RE: 11-16-2018 Technical Revision Response
File No. M2006-017 Jemadojin Sand Mine

Mining and Reclamation Plan

Progressive Mining & Backfill Plan

Jemadojin Mine
M-2006-017
11/28/2018

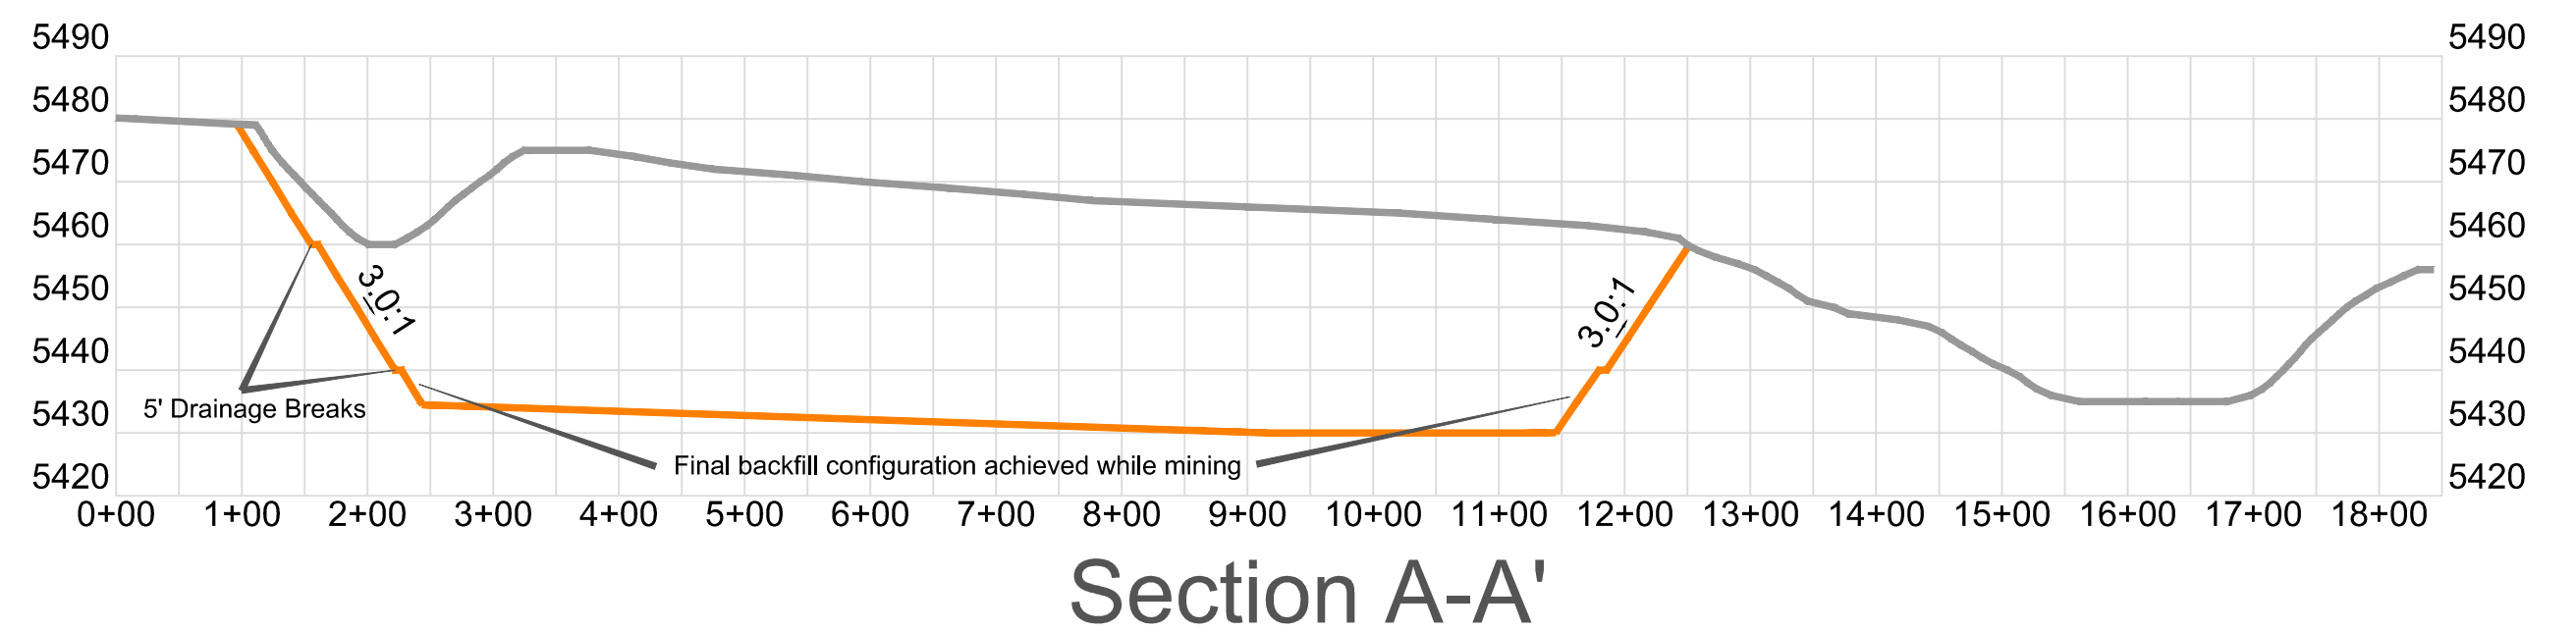
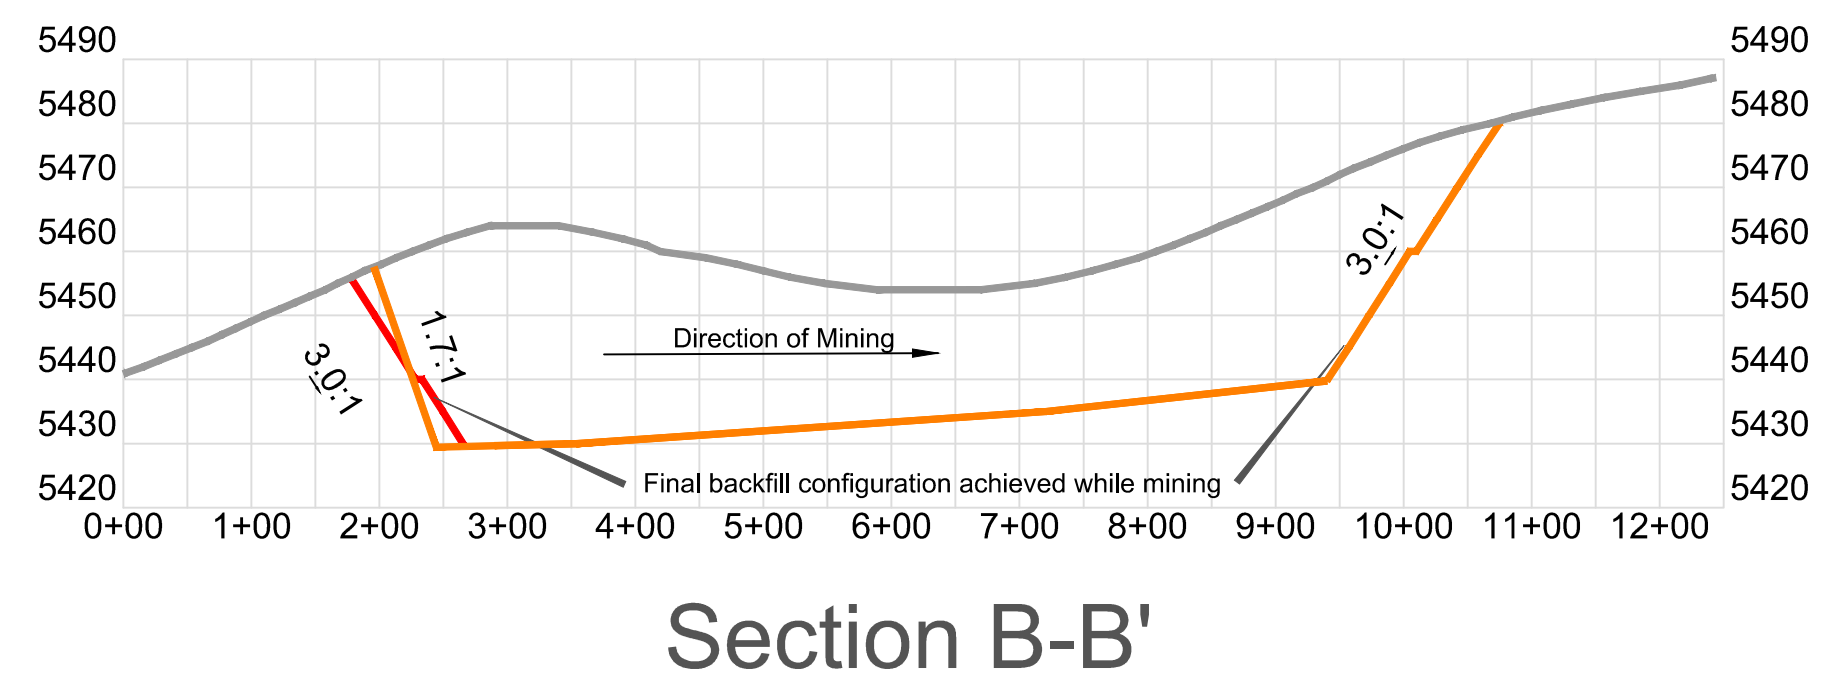
- 1) Figures/Maps: From this point forward, all maps will be numbered with a date or revision number to accurately track the evolution as the permit progresses. A north arrow and scale will be placed on each map. A new backfill plan has been included with a north arrow and scale.

- 2) Commitments: Per our conversation on or about 11/02/2018, it was agreed that Hourglass will not commit to haul back of waste sand to the operation. It was discussed that the upcoming amendment will address backfilling of sand in the pit. The quantities needed for backfill are not required at this time. An updated reclamation plan has been included to show the progressive mining and backfill plan. As shown, the North, East and South highwalls will be progressively mined and reclaimed at a minimum 3:1 slope. The initial West wall will be mined at the angle of repose (1.7:1). Once mining has progressed and the pit opened to give enough room for mining the wall will be pushed in and reclaimed at a minimum of 3:1 slope.

NOTE: Area will be returned to the PMLU of Rangeland per the approved permit.
At least 4 inches of topsoil will be replaced per the approved reclamation plan.
